V2500-A1/A5 SERIES PROPULSION SYSTEMS SERVICE BULLETIN

This document transmits the Initial Issue of Service Bulletin EV2500-75-0085

AIR – HP COMPRESSOR STAGE 10 BLEED VALVE – INTRODUCTION OF PARKER HANNIFIN CORPORATION SUPPLIED BLEED VALVE

AIR	10TH STAGE HIGH PRESSURE COMPRESSOR BLEED VALVE	INTRODUCTION OF 5950041-108 AND UPGRADE OF PART NUMBER (P/N) 5950041-105 AND 5950041-107 TO 5950041-108 BY INCORPORATING A NEW SPRING AND PISTON ASSEMBLY.
-----	---	---

Figure 1

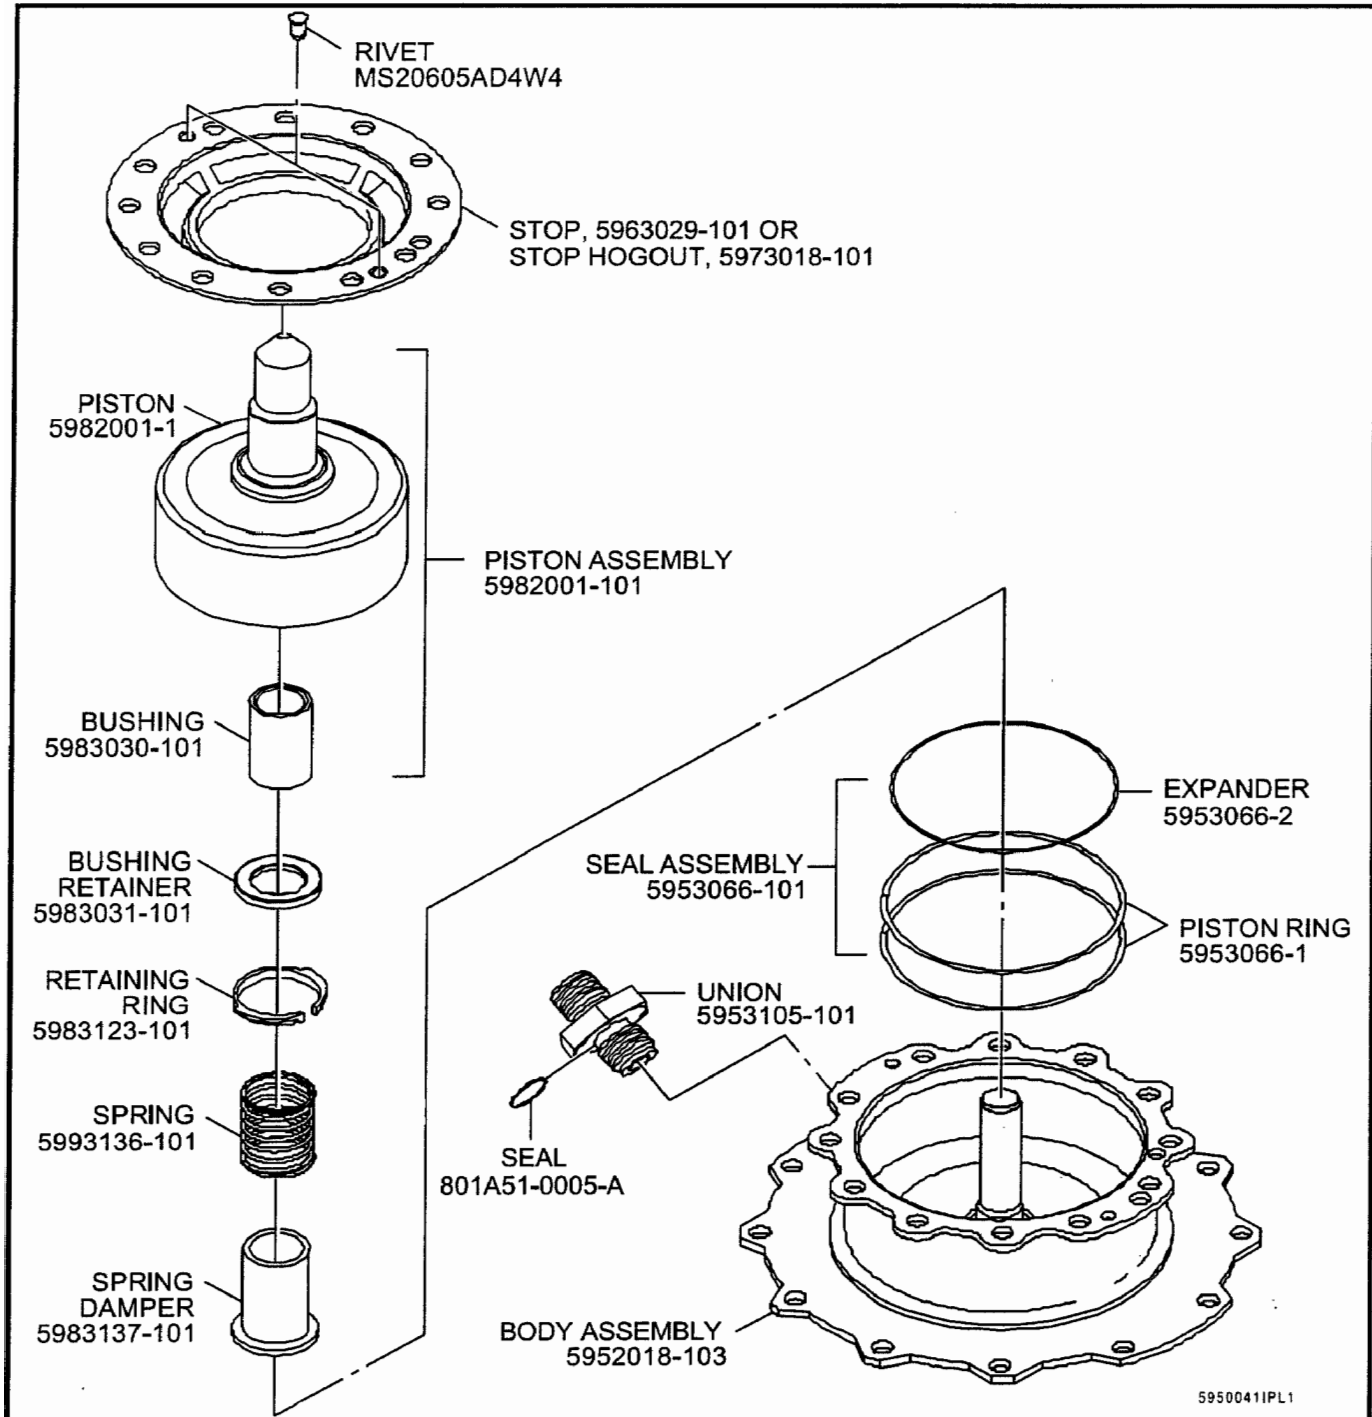
- (1) Remove the union, 5953105-101, from the body assembly, P/N 5952018-103.
- (2) Remove the seal, P/N 801A51-0005-A, from the union, P/N 5953105-101. Discard the seal.

- (3) Mask off the inlet port area of the body assembly, P/N 5952018-103. Use a standard electric drill with a 1/8-inch (3 mm) drill bit, and drill out the two rivets, P/N MS20605AD4W4, from the body assembly. Discard the rivets.
- (4) While holding down on the piston, P/N 5963025-101 or -102, and spring, P/N 5963024-101, remove the stop, P/N 5963029-101 or optional P/N 5973018-101, from the body assembly, P/N 5952018-103. Carefully remove the piston and the spring from the body assembly. Discard the piston and the spring.

- (5) Remove the seal assembly, P/N 5953066-101, from the groove in the body assembly, P/N 5952018-103. Discard the seal assembly.

- (d) Install one piston ring, P/N 5953066-1, from the seal assembly, P/N 5953066-101, into the groove of the inside diameter of the body assembly, P/N 5952018-103. Set the gap at 110 to 130 degrees from the expander gap.
- (e) Install the second piston ring, P/N 5953066-1, and set the gap at 110 to 130 degrees in the opposite direction from the expander gap.
- (f) Install the spring damper, P/N 5983137-101, into the body assembly, P/N 5952018-103.
- (g) Install the spring, P/N 5993136-101, into the groove in the body assembly, P/N 5952018-103.
- (h) Install the bushing retainer, P/N 5983031-101, followed by the retaining ring, P/N 5983123-101, into the piston assembly, P/N 5982001-101.

- (i) Compress the seal assembly, P/N 5953066-101, by hand from the outlet port of the body assembly, P/N 5952018-103, and carefully install the piston assembly, P/N 5982001-101, over the spring, P/N 5993136-101, and into the inlet port of the body assembly.

- (j) Put the body assembly, P/N 5952018-103, on a bench. Install the stop, P/N 5963029-101 or optional 5973018-101, onto the body assembly and line up the bolt holes and the rivet holes.
- (k) Compress the spring until the stop's flange bottoms onto the body assembly, P/N 5952018-103, and clamp them together.
- (l) Rivet Installation
 - 1 Use a hand-held blind rivet gun and install the rivet, P/N MS20605AD4W4, in two places. Seat the head of the rivet in the countersink of the stop and buck the rivets.
 - 2 Make sure that the head of the rivet, P/N MS20605AD4W4, is in full contact with the countersink after bucking, but it is acceptable if the rivet is loose and can rotate in the hole by hand.
 - 3 The expanded portion of the rivet shank must not show signs of cracking, and the rivet stem must not break off inside the rivet.

- (m) Install the seal, P/N 801A51-0005-A, onto the non-countersink end of the union P/N 5953105-101.
- (n) Install the union, P/N 5953105-101, into the servo port of the body assembly, P/N 5952018-103. Make sure that the seal, P/N 801A51-0005-A, seats into the countersink of the servo port.
- (o) Apply a torque of 20 to 24 ft-lb (27 to 33 N·m) to the union, P/N 5953105-101.
- (p) Use lockwire, MS20995N25, per MS33540, using a double-twist method, and lockwire the union, P/N 5953105-101, to the body assembly, P/N 5952018-103.

Seal Assembly
Figure 2

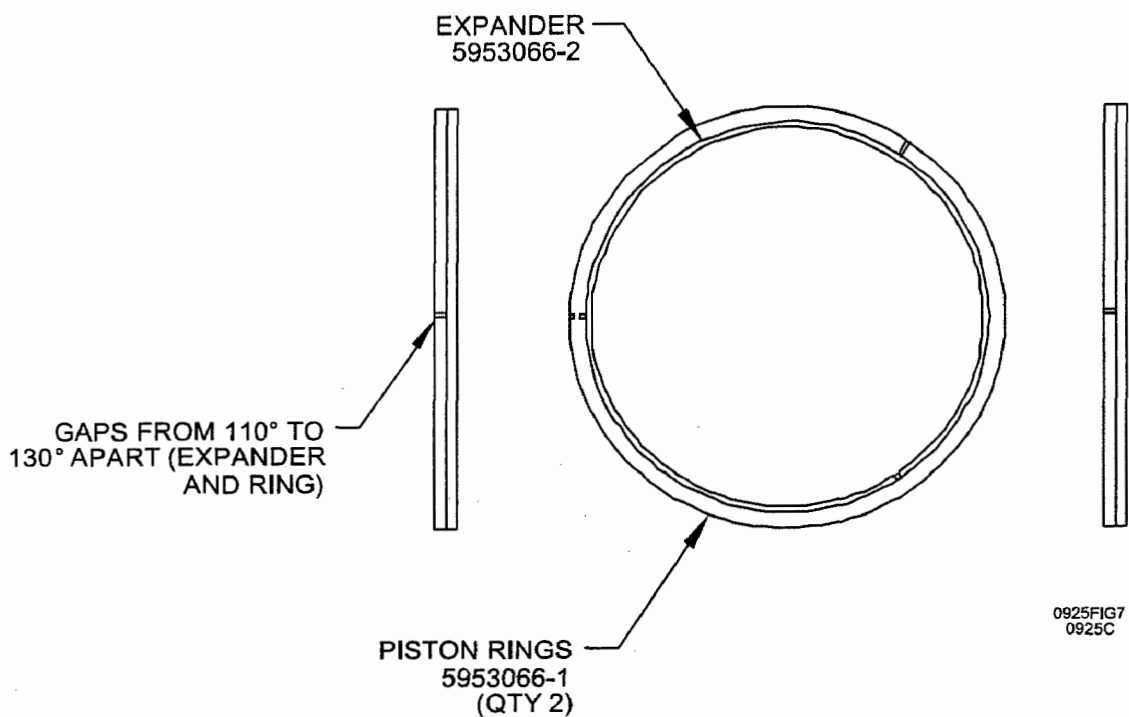
- (1) Assembly of seal assembly, P/N 5953066-101, (See Figure 2)
 - (a) Install the expander, P/N 5953066-2, into the groove of the inside diameter of the body assembly, P/N 5952018-103.

- (c) Check the piston rings, P/N 5953066-1, for any evidence of sticky residue. If necessary, clean the piston rings by wiping with a cloth dampened with isopropyl alcohol, TT-I-735, and dry with compressed air at a maximum nozzle pressure of 30 psig (207 kPag).

Proof Pressure Test Setup
Figure 3

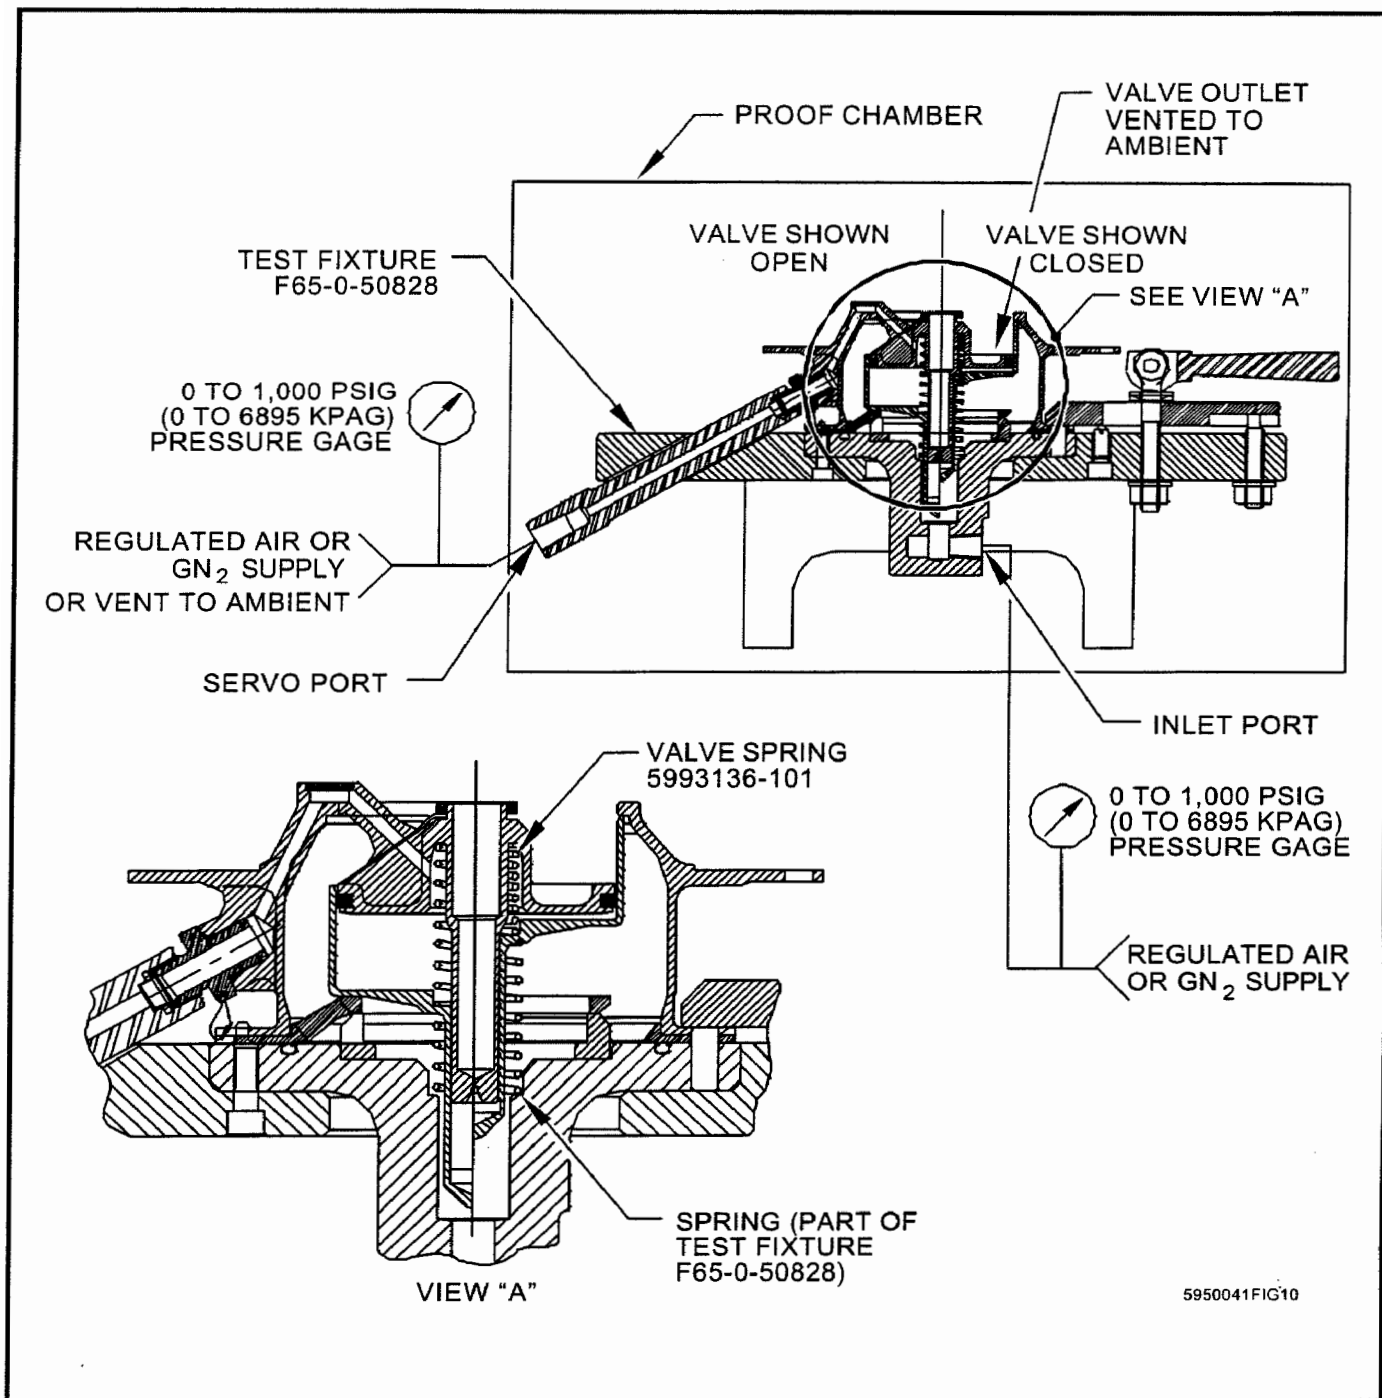
- (a) Set up the valve, as shown in Figure 3, in test fixture, F65-0-50828, and the outlet and inlet ports of the valve vented to ambient.
- (b) Slowly apply a pressure of 625 to 635 psig (4309 to 4378 kPag) to the servo port and hold the pressure for a minimum of 1 minute.
- (c) Slowly reduce the pressure to zero.
- (d) There must be no deformation or other permanent damage.

- (a) Set up the valve, as shown in Figure 3, in test fixture, F65-0-50828, and the outlet and the servo ports vented to ambient.
- (b) Slowly apply a pressure of 585 to 595 psig (4033 to 4102 kPag) to the inlet port and hold the pressure for a minimum of 1 minute.
- (c) Slowly reduce the pressure to zero.
- (d) There must be no deformation or other permanent damage.

Leakage Test Setup
Figure 4

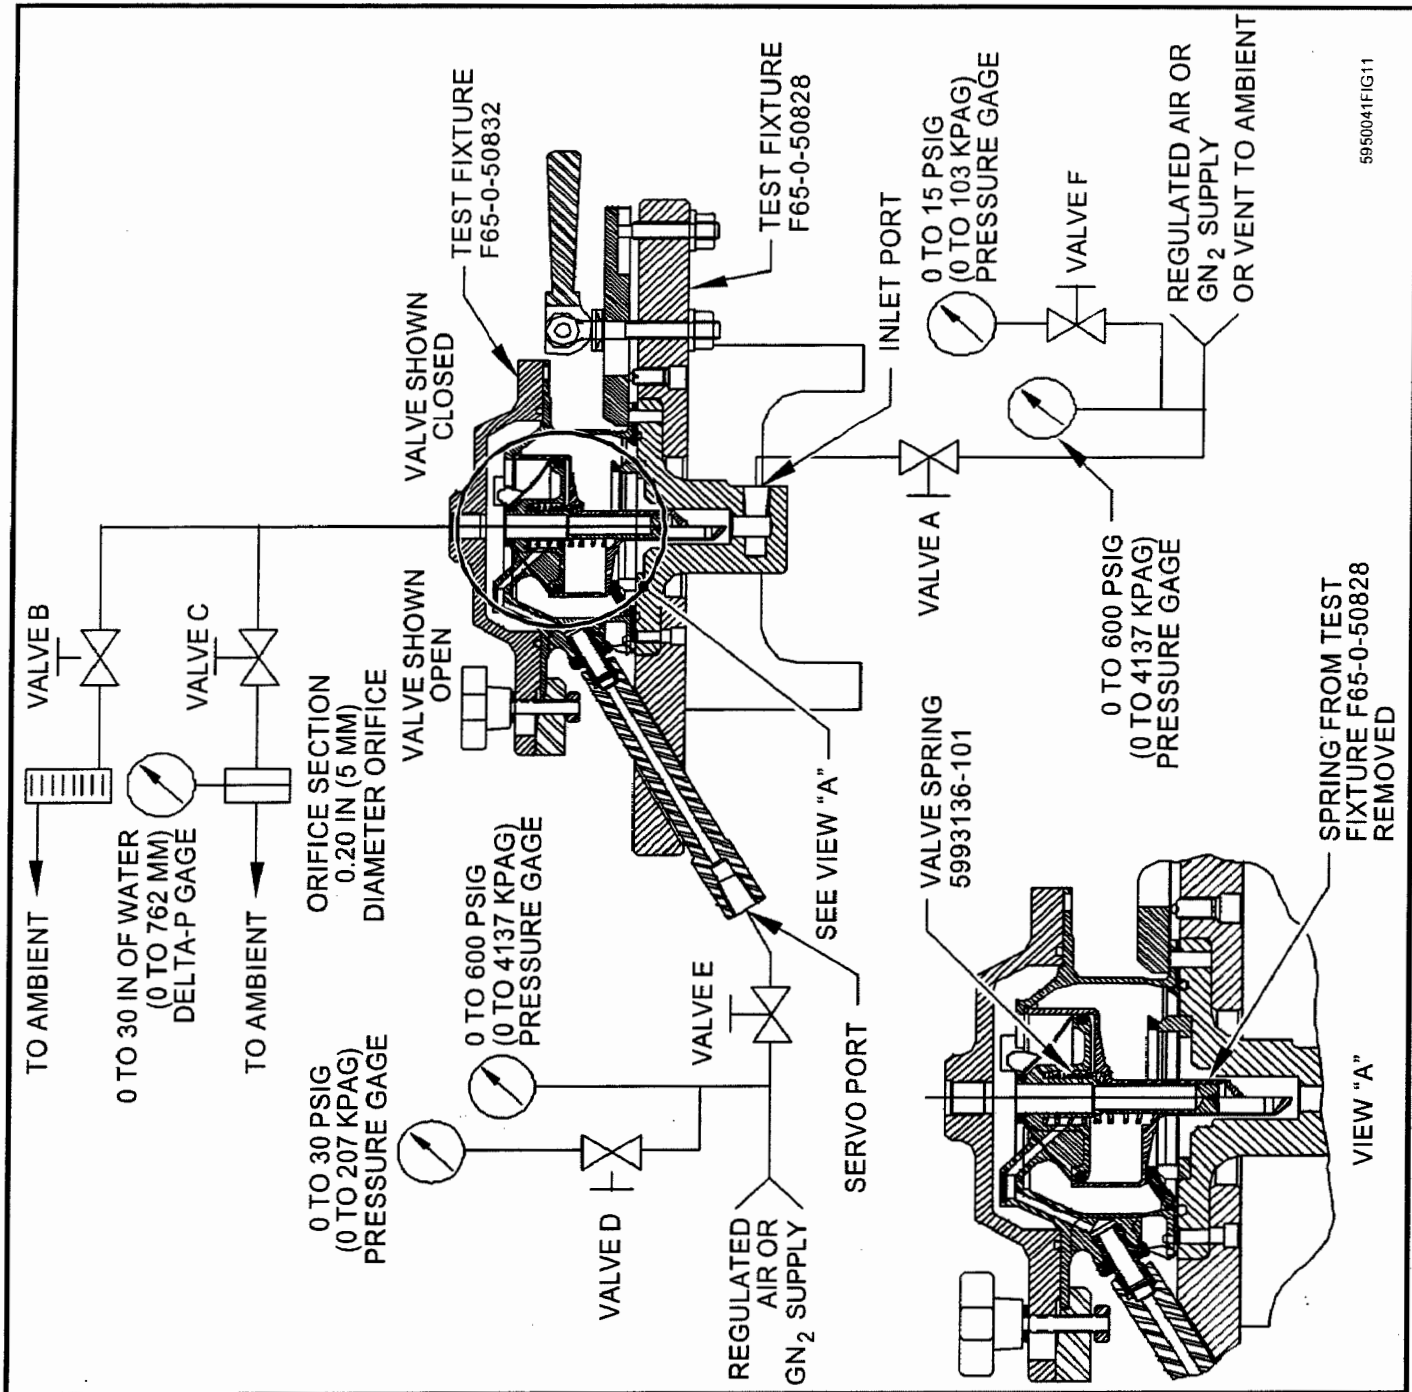
- (a) Set up the valve, as shown in Figure 4, with the spring removed from the test fixture, F65-0-50828. Close valves A and F and open valves D and E.

- (b) Slowly apply a pressure of 25 to 35 psig (172 to 241 kPag) to the servo port, then slowly reduce the pressure to 2.9 to 3.1 psig (20 to 21 kPag) to the servo port and hold the pressure for a minimum of 1 minute.

- (c) The servo leakage must not exceed 0.170 scfm (0,0048 scmm) (equivalent to 0.013 lbs/minute [0,006 kg/minute]), as measured at the flowmeter.
- (d) Slowly reduce the pressure to zero.

- (e) Close valve D.
- (f) Slowly apply a pressure of 345 to 355 psig (2379 to 2448 kPag) to the servo port and hold the pressure for a minimum of 1 minute.

- (g) The servo leakage must not exceed 2.6 scfm (0,0736 scmm) (equivalent to 0.20 lbs/minute (0,009 kg/minute)), as measured at the flowmeter.
- (h) Slowly reduce the pressure to zero.

- (a) With the spring still removed, set up the valve in test fixture, F65-0-50828, as shown in Figure 4. Close valves D and F. Open valves A and E.
- (b) Slowly apply pressure to the inlet port until the valve closes. Close valve E.
- (c) Slowly increase the pressure to 330 to 340 psig (2275 to 2344 kPag) to the inlet port.
- (d) The leakage must not exceed 2.8 scfm (0,079 scmm) (equivalent to 0.21 lbs/minute (0.10 kg/minute)), as measured at the flowmeter.
- (e) Slowly reduce the pressure to zero.

Operating Pressures Test Setup
Figure 5

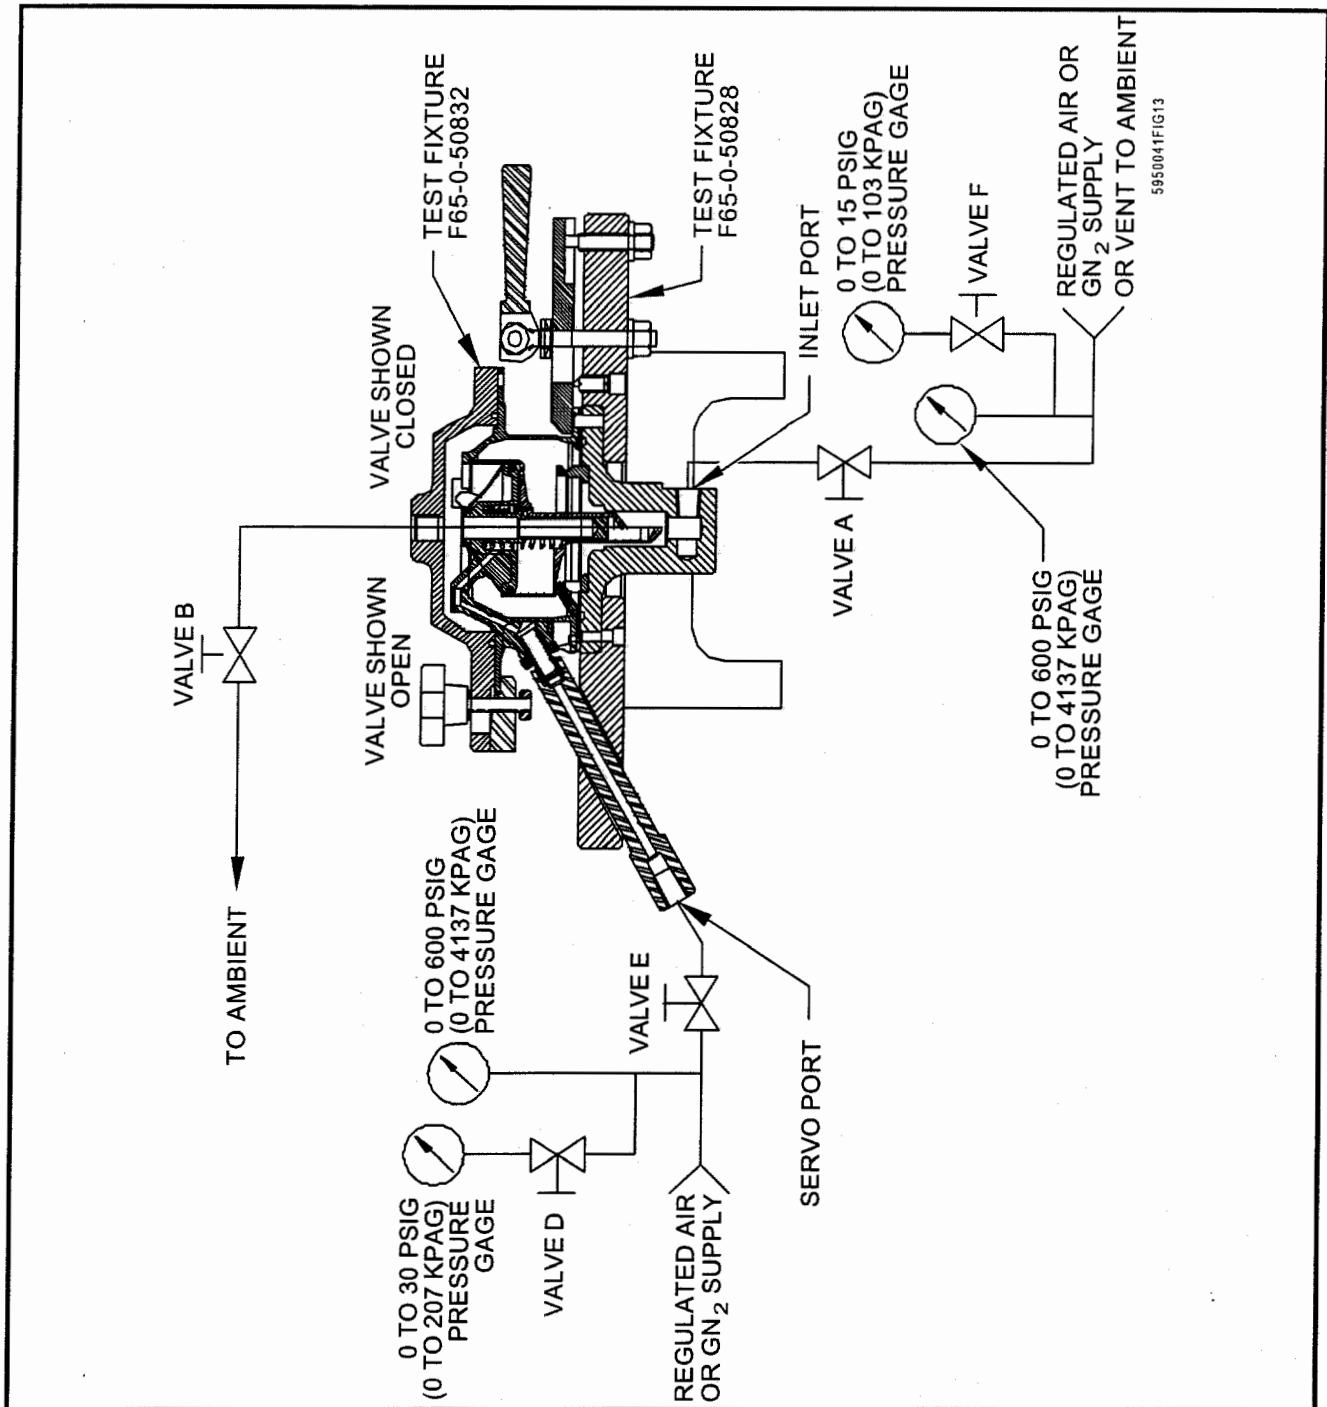
- (a) With the spring still removed, set up the valve in test fixture, F65-0-50828, as shown in Figure 5. Open valves A, D, E, and F.

- 1 Vent the servo pressure to zero.
- 2 With the inlet pressure at zero, partially close valve B while slowly increasing the inlet pressure to close the valve.

- 3 The valve must close at a maximum pressure of 3 psig (21 kPag).
- 4 Reduce the inlet pressure to zero to open the valve.

- 1 Vent the servo pressure to zero.
- 2 With the inlet pressure at zero, partially close valve B while slowly increasing the inlet pressure to 2.9 to 3.1 psig (20 to 21 kPag) to close the valve.

- 4 The valve must open at a maximum servo pressure of 5 psig (34 kPag).
- 5 Reduce the servo pressure to zero to close the valve.
